Phillips 66
Bayway Refinery
P.O. Box 222
1400 Park Avenue
Linden, New Jersey 07036

NJPDES Permit NJ0001511
Program Interest ID #46318
Inspection Report & NOV Response

**Bayway Refinery Response to
January 3, 2020 Compliance Evaluation Inspection (CEI)
Report & December 26, 2019 Notice of Violation (NOV)
NJPDES Surface Water Discharge Permit NJ0001511: Program Interest ID #46318**

Figure 1: RR Ave
Ditch Area

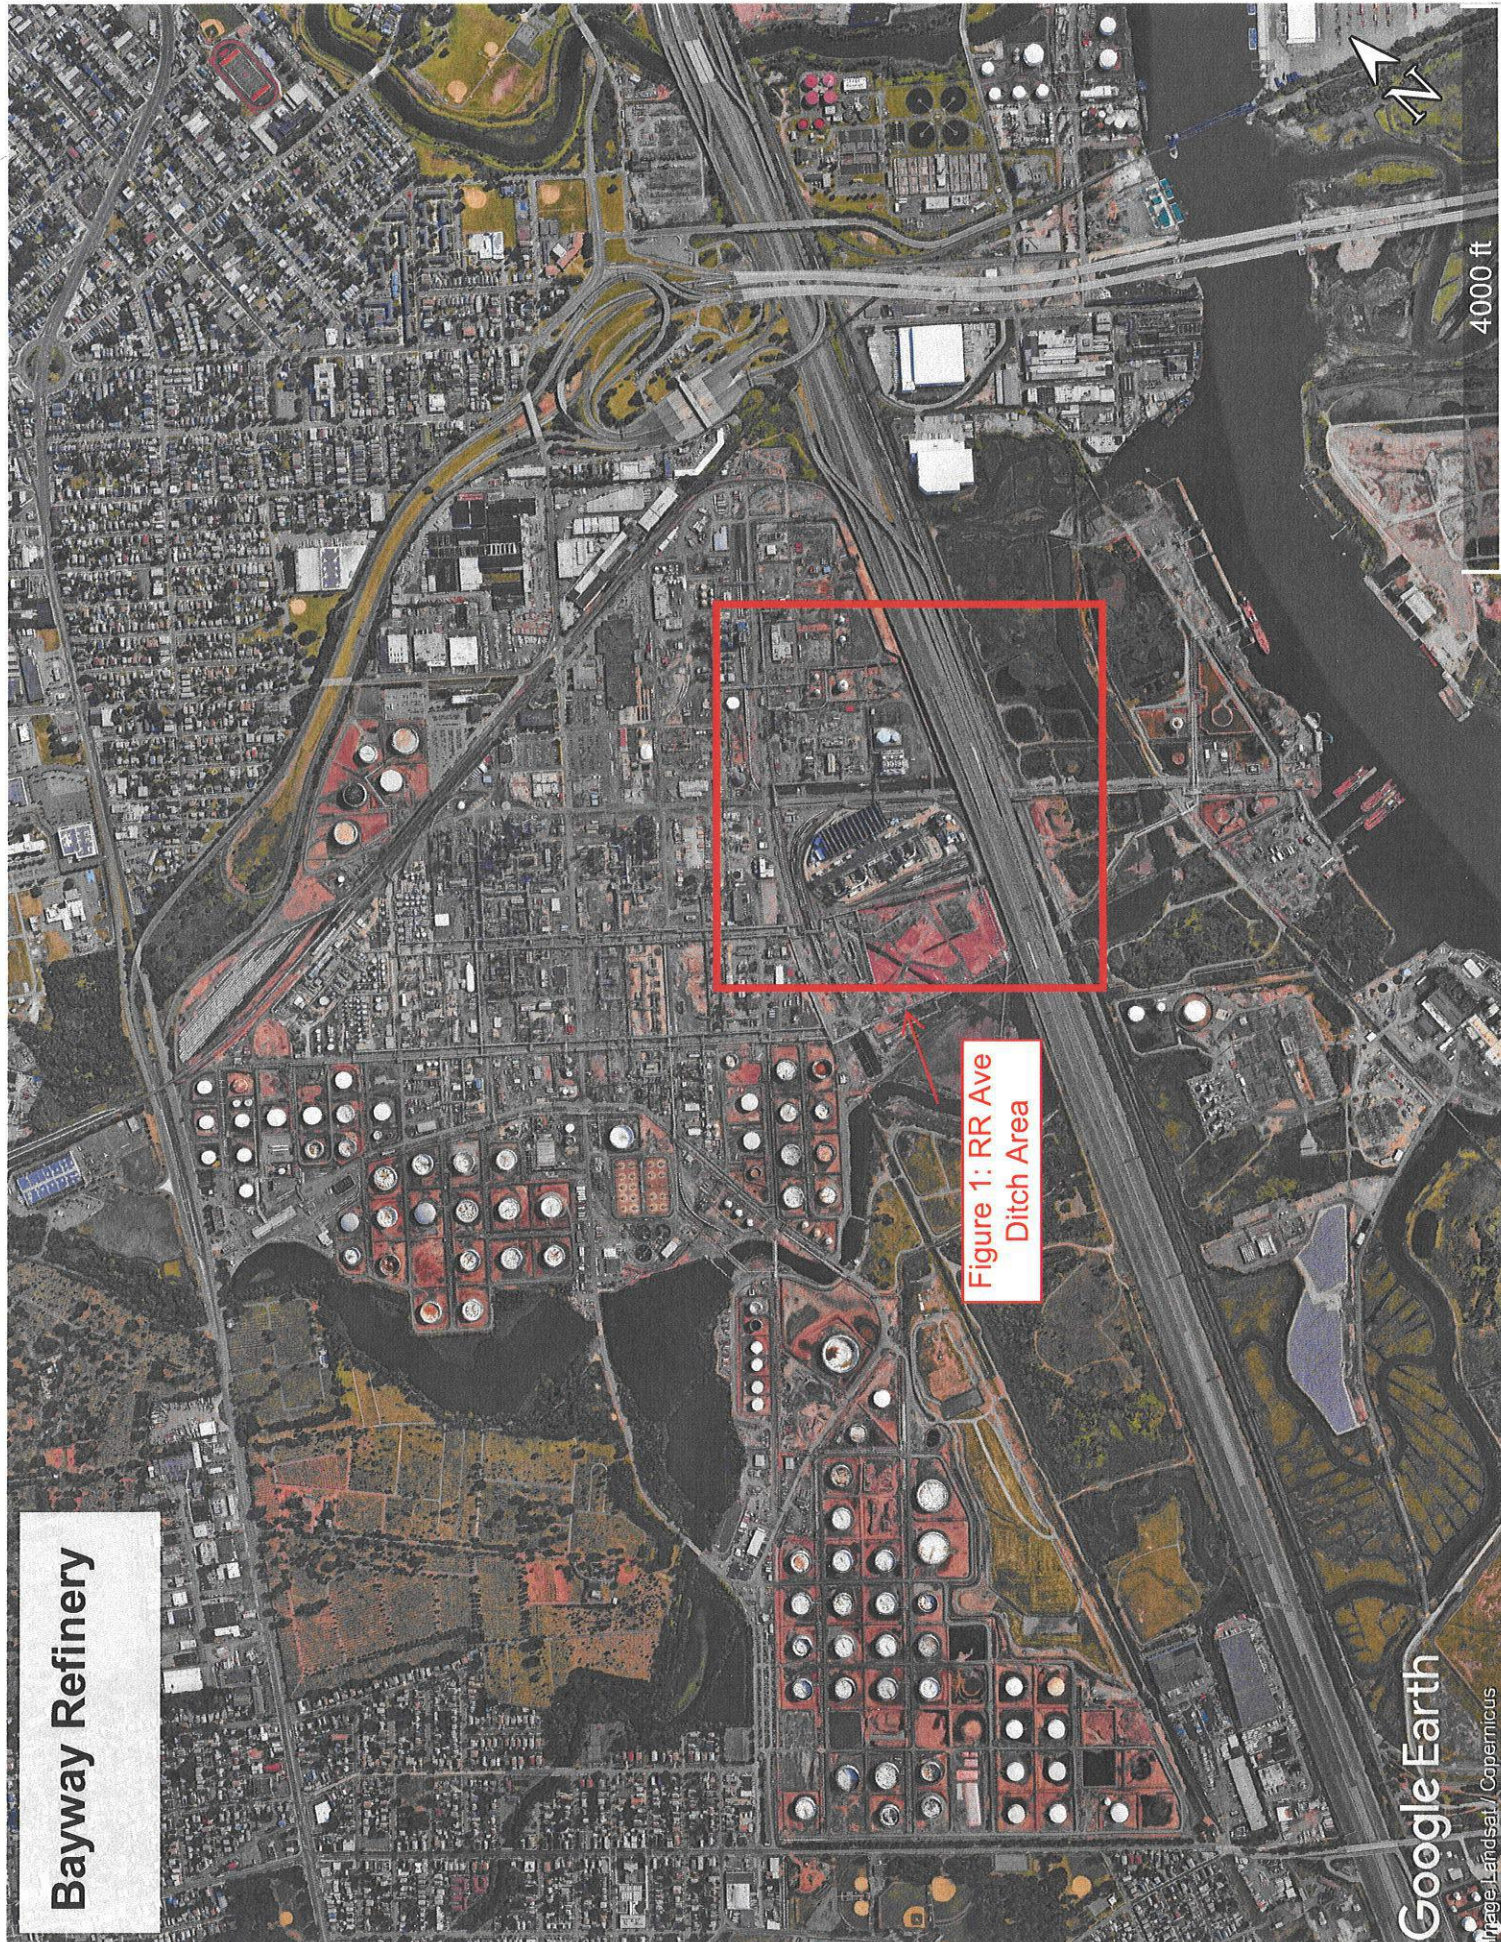
Improper operation of the Polypropylene ("PE") Pellet Separator causing an unpermitted discharge of PE to the Morses Creek on June 20. The separator treats water used to wash the interior of rail cars previously filled with PE pellets and fluff. Wash water enters one end of a large rectangular separator which traps floating pellets and allows water to discharge through an underflow partition at the other end. During the June 20 inspection, P66 had installed several aerators in the chamber to stir up the water, reportedly to move the pellets to a designated area for removal. However, the mixing motion of the aerators churned the PE pellets into the water column, negating the role of the chambers final partition to capture the floating pellets. A circular screen designed to fit over the chamber outfall was hanging from a railing in the immediate vicinity and not in use. A steady flow laden with pellets was observed discharging from the chamber. See the attached photos. Video was also collected.

The Department first became aware of these pellets at a location in the Morses Creek near your DSN 005 outfall. A vactor truck was actively removing a large accumulation of floating pellets that had collected in a series of booms. This writer had no data to suggest what percentage of pellets were collected by these booms.

PE pellets (though much fewer than June 20) were still noted at the same boomed collection area near DSN 005 in the Morses Creek during the October 29 inspection. See the attached photo.

The DSN 005A discharge monitoring point is located within Railroad Avenue Ditch upstream of additional floating material containment facilities. It was selected for monitoring for several reasons, including safety (existing hand rails, no need to walk on stone or sample from sloped banks along the ditch), easy access to sample the center of the ditch flow, and upstream of rain downspouts that discharge NJ Turnpike runoff into Railroad Avenue Ditch. It's selection for monitoring fully recognized that there were additional downstream containment facilities in Railroad Avenue Ditch, but NJDEP preferred to stay upstream of the NJ Turnpike downspouts; this became irrelevant during the permitting process when NJDEP decided that DSN 005A should only be sampled during dry weather. The Polypropylene Separator cannot discharge directly into Morses Creek and its discharge must first flow through the Railroad Avenue Ditch and DSN 005A. Figure 1 shows the resin separator, Railroad Avenue Ditch, the observed containment boom within Railroad Avenue Ditch underneath the NJ Turnpike, the DSN 005A

monitoring point, the Railroad Avenue Ditch dam, and the Railroad Avenue discharge point into Morses Creek, as described above.

- Railroad Avenue Ditch continues for over thousand feet after the containment boom where the plastic residual and scum was photographed within the containment boom under the NJ Turnpike overpass by NJDEP on June 20 for recovery by vacuum trucks, which were actively skimming the contained floating material at the time. This boom is not located within a receiving waterbody. DSN 005A sampling point is located downstream of the cited collection point, as are additional containment facilities.

As described in response to Deficiency #1, P66 already employs "additional measures to ensure that PE pellets and fluff are not discharged from the separator to the Morses Creek and the surface waters of the State." These additional measures include the containment booms within Railroad Avenue Ditch upstream of DSN 005A that were photographed by NJDEP, as well as additional containment booms downstream of the DSN 005A monitoring point but still upstream of the DSN 005A discharge into Morses Creek. However, Bayway still intends to implement additional measures to reduce plastic residual from entering Railroad Avenue Ditch. Bayway has already committed to installing a cover over the separator outlet, improving waste management contractor performance, and implementing oversight of the pellet separator by N licensed operators as discussed in response to inspection report deficiencies. Bayway also intends to evaluate the potential use of screens, fences and/or curtains for the baghouse exhaust roll-off area in 2020 if current equipment trials with roll-off covers are not considered successful.

Figure 2: Poly
Ditch Area

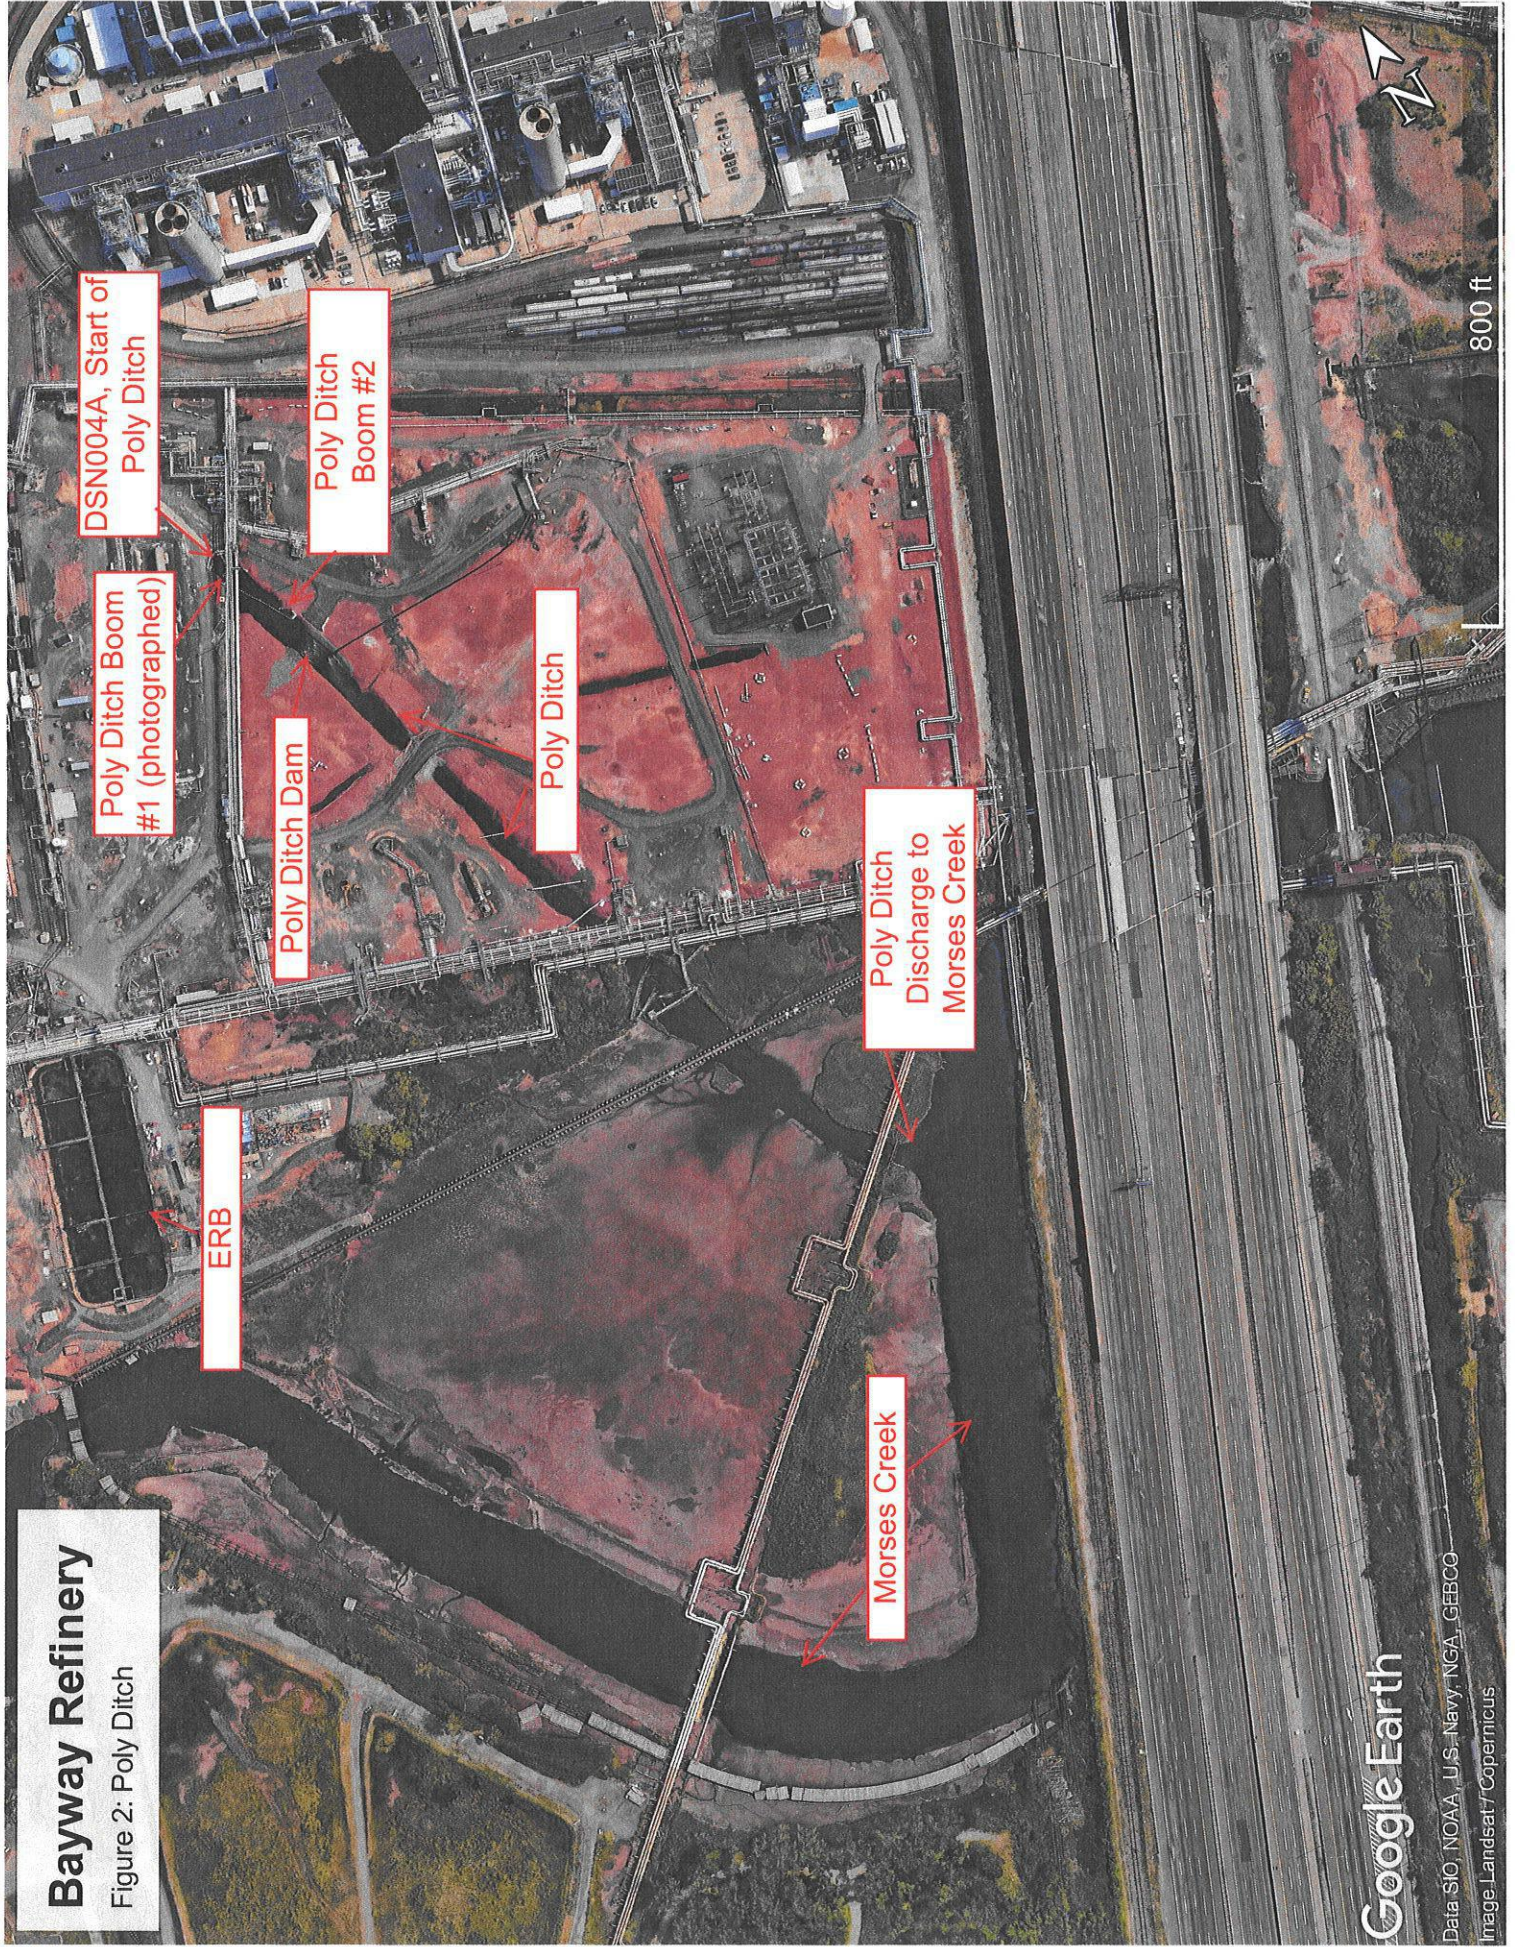
During the inspection on June 20, an oily floating substance was trapped behind the boom at your DSN 004 outfall. See the attached photo. Reportedly, a vactor truck was dispatched to skim this material. On the date of the inspection, P66 was adding a pesticide called Clam-Trol (allowed by its Permit) to its salt water intake to kill Mollusca, Barnacles, Hydrozoa, Bryozoa, and Bacterial, Fungal and Algal Slime in its cooling water system. According to representatives of P66, Clam-Trol material is added annually. However, P66 is hereby REQUIRED to create BMPs for the collection and removal of this material at DSN 004 during times (and immediately afterwards if necessary) when this chemical is added.

On the October 29 inspection, a light sheen was noted behind the boom at the DSN 004 outfall.

DSN 004A is known onsite as Poly Ditch. Similar to Tremley Ditch and Railroad Avenue Ditch, Poly Ditch is a manmade ditch constructed to convey refinery discharges to Morses Creek. Poly Ditch is not a receiving waterbody. Poly Ditch starts at the outlet of a culvert which discharges commingled stormwater and cooling water into Poly Ditch. Similar to Tremley Ditch and Railroad Avenue Ditch, the Poly Ditch has a low level overflow dam over one thousand feet upstream of its discharge into Morses Creek. The dam maintains a constant water level in the upstream portion of the ditch allowing two containment booms to capture sheen and other floating material that enters the Poly Ditch (e.g. from equipment leaks or road run-off draining into the Poly Ditch). The dam and spill booms together are a significant BMP that supplements other BMPs. The dam and booms were specifically installed to reduce the chance of oil and other floating material from spills, leaks and stormwater runoff from entering Morses Creek. Similar to Tremley Ditch and Railroad Avenue Ditch, Poly Ditch is not a receiving waterbody, it is a conveyance. Figure 2 shows Poly Ditch, the dam and spill booms within Poly Ditch, and the Poly Ditch discharge point into Morses Creek, as described above.

The DSN 004A discharge monitoring point is located at the sewer outlet into Poly Ditch upstream of the two containment booms and associated overflow dam. It was selected for monitoring for several reasons, including safety (existing hand rails, no need to walk on stone or sample from sloped banks), easy access to sample the center of the ditch flow, and being located outside of the butane and propane storage area that Poly Ditch runs through, which requires gas testing by a process operator before entry to ensure safe conditions. Selection of this point for monitoring fully recognized the downstream containment facilities in Poly Ditch.

Poly Ditch continues for over one thousand feet after the first containment boom where the floating material was observed contained on June 20. The floating material was predominantly biological scum being released in response to the ongoing molluscicide treatment. Note that biological scum can have a dull sheen that is similar in appearance to dull sheen from oil, depending on the oil source and quantity. Regarding the light sheen observed on October 29, we again note that the sheen was contained within the first containment boom within Poly Ditch. We also note that the amount of material collected at the containment boom on both days was very small relative to the over 10 million gallons of day of continuous flow into Poly Ditch, that there was no ongoing observable sheen discharging from the upstream sewer into Poly Ditch on either day, no sheen was observed past the first boom, and that Bayway verified that there were no equipment oil leaks into Poly Ditch on either day. The Poly Ditch receives runoff from an area that includes paved surfaces, streets and parking areas. With some rain preceding both inspection days, the most likely source of the nominal amount of sheen observed would have been road runoff and/or biological scum resulting from biocide treatment, which is generally conducted daily using bleach (bleach treatment is separate from the molluscicide treatment). Regardless of the source of the floating material, the containment boom was functioning as designed, allowing subsequent recovery by vacuum truck. The need for vacuum trucks is determined through normal operator rounds, which include checking the spill booms in Poly Ditch at least once per shift. This floating material containment system is one of several BMPs already in place and proven to be effective as observed by NJDEP and USEPA.
